Access Compliance Report

Public Rights-of-Way

Intersection ID: 13553	Main Street: WINGATE_AV	Cross Street: DODGE_AV	Location: SE
ADA ID: 45CE63DBF809	Ramp Type: PerpDiag	Initial Pass/Fail: Fail	Overall Compliance: No
Severity Score: 12.5			
Codes/Mitigation Info/Possible Solution		Field Measurements/Component Compliance

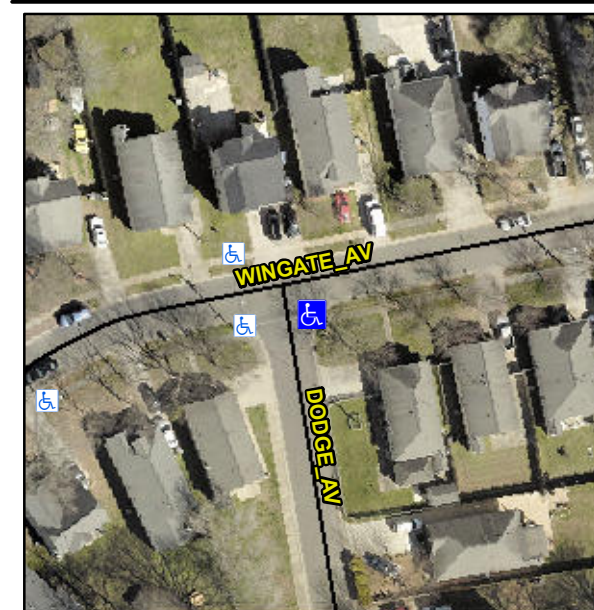
Not Found, R304.2.2

Compliance	Description	Data	Compliance	Description	Data
N/A	Ramp Length (in)	44.0	No	Ramp Slope (%)	8.9
Yes	Ramp Width (in)	48.0	Yes	Ramp XSlope (%)	1.3
N/A	Flare Type LT	N/A	N/A	Flare Type RT	N/A
N/A	Flare Slope LT (%)	N/A	N/A	Flare Slope RT (%)	N/A
N/A	Flare Traversable LT?	N/A	N/A	Flare Traversable RT?	N/A
N/A	Landing Length (in)	N/A	N/A	DWS Provided?	N/A
N/A	Landing Width (in)	N/A	N/A	DWS Contrast?	N/A
N/A	Landing Slope (%)	N/A	N/A	DWS Length (in)	N/A
N/A	Landing X Slope (%)	N/A	N/A	DWS Full Width?	N/A
N/A	Landing Curb? (Y/N)	N/A	N/A	DWS Offset (in)	N/A
N/A	Shared Landing?	N/A			
N/A	Gutter Ponding?	N/A	N/A	Gutter Slope (%)	N/A
N/A	Gutter Lip Ht (in)	N/A	N/A	Gutter X Slope (%)	N/A
N/A	Painted X Walk1?	No	N/A	Painted X Walk2?	No
	X Walk 1 Direction	To N		X Walk 2 Direction	To W
N/A	X Walk 1 Width (in)	N/A	N/A	X Walk 2 Width (in)	N/A
	X Walk 1 Slope (%)	4.3		X Walk 2 Slope (%)	1.6
	X Walk 1 X Slope (%)	1.7		X Walk 2 X Slope (%)	1.5

Remove & Replace Curb Ramp With Two New Directional Ramps or Equivalent.
